PREVOST

Mi98-06

DATE: March 1998	SECTION: 22
SUBJECT: REPLACEMENT OF PLASTIC BRACKETS

FIGURE 2: PLASTIC BRACKETS (TYPICAL INSTALLATION)

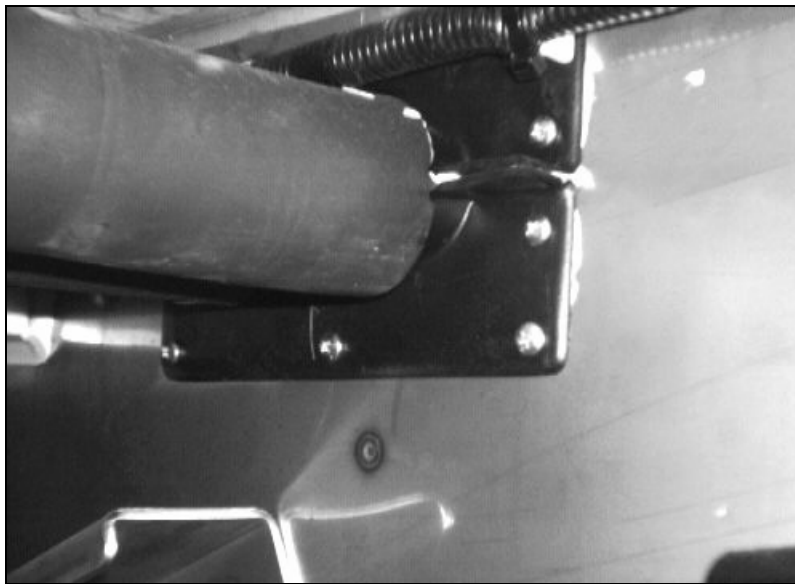
On the above-mentioned vehicles, the plastic brackets located in rear baggage compartment supporting the high pressure tubes may melt due to extreme heat which may cause leaks on high pressure side of A/C system.

1. In rear baggage compartment (refer to fig. 1), cut locking ties and move cables out of the way if necessary.
2. Take out screws from plastic brackets then remove brackets (refer to fig. 2). Set screws aside.
3. Remove Sikaflex 221 sealant and clean surface.
4. Apply Sikaflex 221 sealant onto the wall then fix stainless steel brackets (Prévost #453145) using screws.
5. Secure cables using locking ties.

Part No.	Description	Qty
453145	Stainless Steel Bracket	2
